**LEXINGTON-FAYETTE URBAN COUNTY  
GOVERNMENT CONTRACT CHANGE ORDER**  
Page 1 of 2

Date:	December 28, 2015
Project:	Senior Citizen Center Construction
Location:	Lexington
Contract No.:	227-2014
Original Contract Amt.:	\$8,882,900.00
Cumulative Amount of Previous Change Orders	\$1,417,353.37
Percent Change - Previous Change Orders	15.96%
Total Contract Amount Prior to this Change Order	\$10,300,253.37
Change Order No.:	33

CHANGE ORDER NO. 33

**Pending Owner Approval**  
**PR-57 Credit for the Sunscreen Columns per Proposal Request No. 41**

LFUCG Senior Center  
October 29, 2015  
L4.0

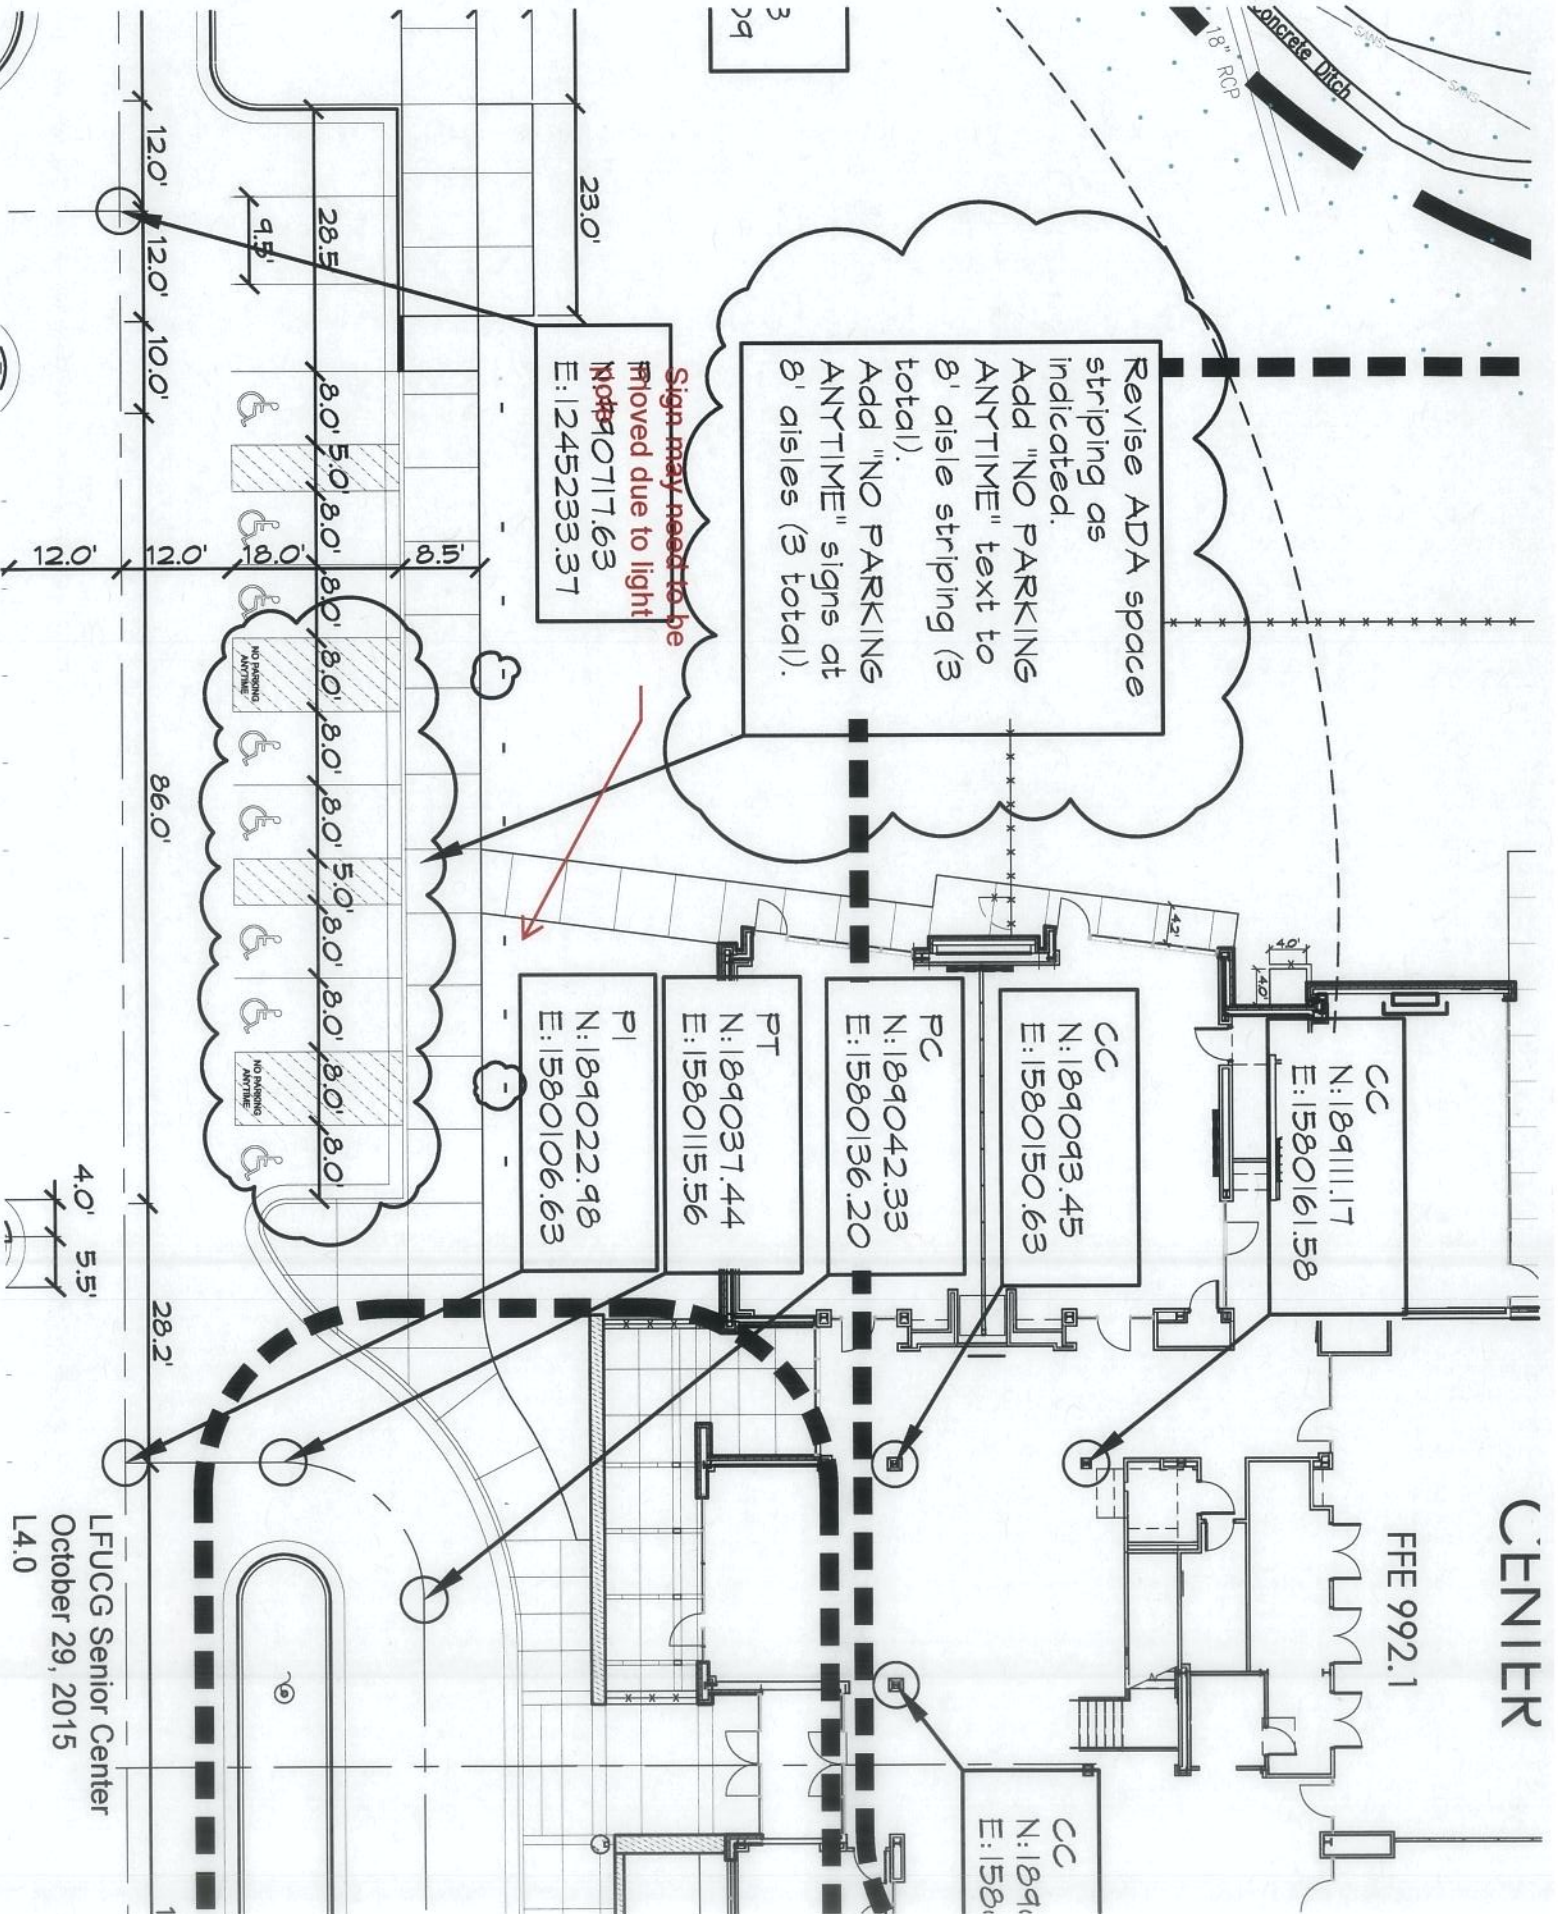
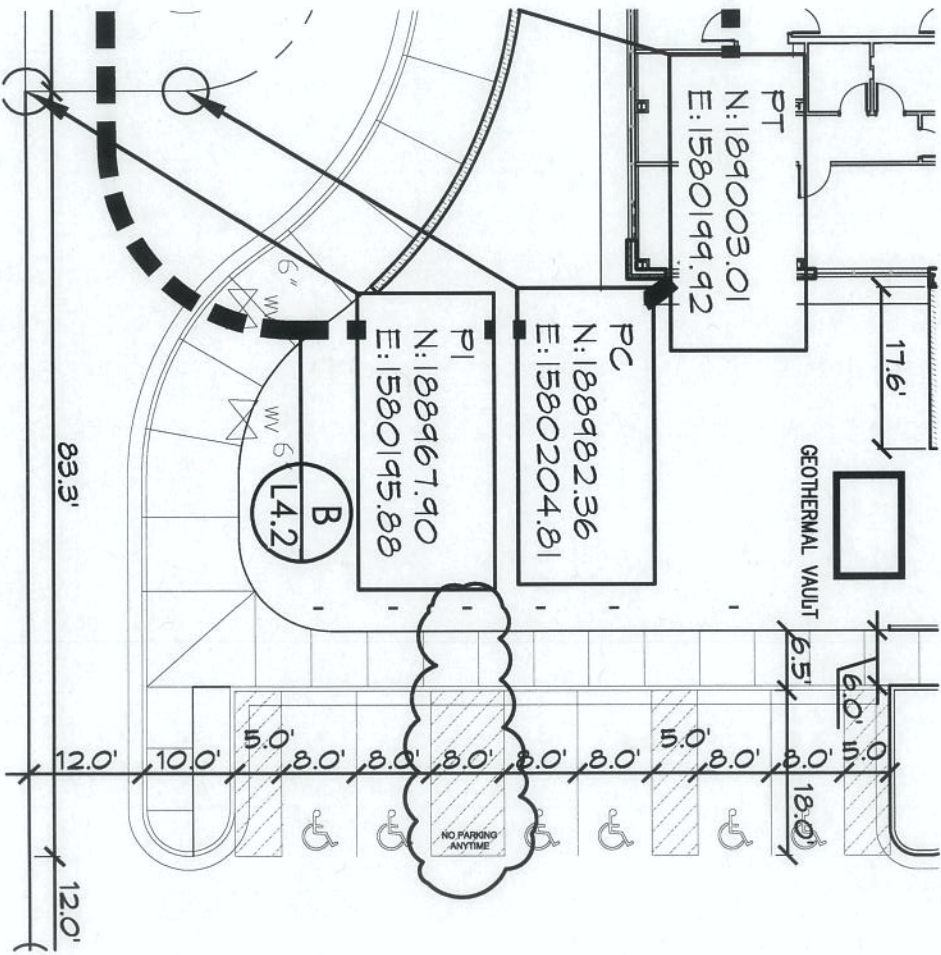
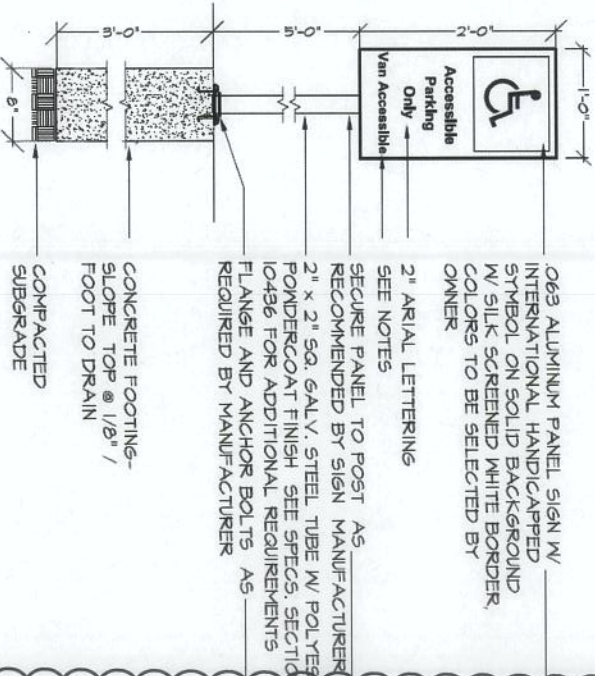
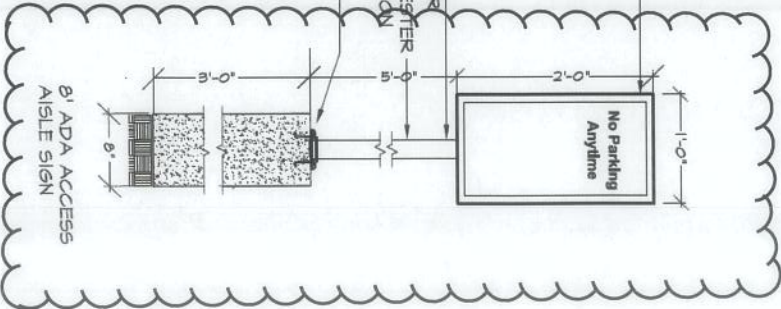
Please provide pricing to furnish additional parking signs and to add "NO PARKING ANYTIME" paint to van access areas, as directed by ASI-053.

Please revise the two areas described in the attached sketches as directed. Parking layout sketch will revise the striping and add signs as directed by the LFUCG accessible parking ordinance. Revisions to the pickleball court grading are the result of discussions at the October 29 pre-construction meeting. Please locate the court with relation to the existing sanitary manhole to ensure appropriate grading.

Please add (1) additional parking sign at the van access zone in the lower parking lot. Follow all directions of ASI-053 and PR-046 for provision and installation.
